TORQUE CHECK OF 2006 ROCKET III, ROCKET III CLASSIC AND ROCKET III SPECIAL EDITION HANDLEBAR BOLTS

OFFICIAL RECALL NOTICE
N.H.T.S.A. No. 06V-063
SERVICE BULLETIN 371

Recall Action Notice Service Bulletin 371

- Instrument bracket
- Screws

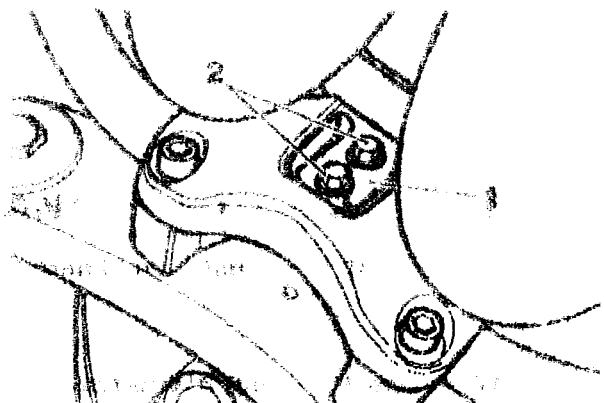
- To gain access to the handlebar clamp bolts it is necessary to remove the instrument and bracket assembly from the handlebar clamp.
- Carefully remove the chrome cover from the instrument bracket.

- Support the instrument, undo and remove the two screws securing the instrument bracket to the handlebar clamp then lift the instrument and bracket assembly clear.

- Handlebar clamp
- Handlebar clamp bolts

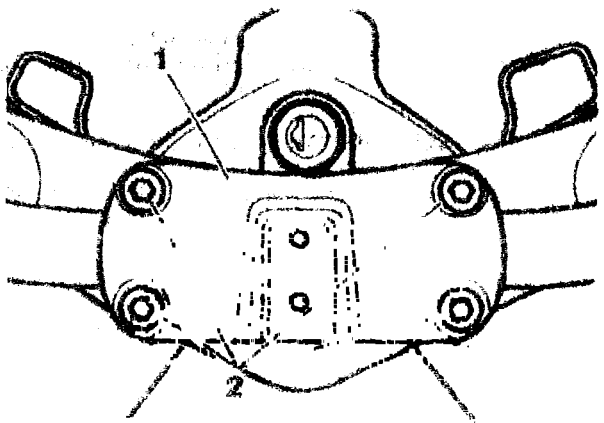
From VIN 241570, the design of the handlebar clamp on the above models changed. The new handlebar clamp requires that the clamp bolts be tightened to 45 Nm.

Although this information was released in Technical News Issue 84, it is possible that the handlebar clamp bolts on some motorcycles from VIN 241570 have been tightened to the incorrect torque.

- Ensure that all four handlebar clamp bolts are tightened to 45 Nm.

- Position the instrument and bracket assembly to the handlebar clamp and secure with the two screws. Tighten the screws to 9 Nm.
- Carefully fit the chrome cover to the instrument bracket.
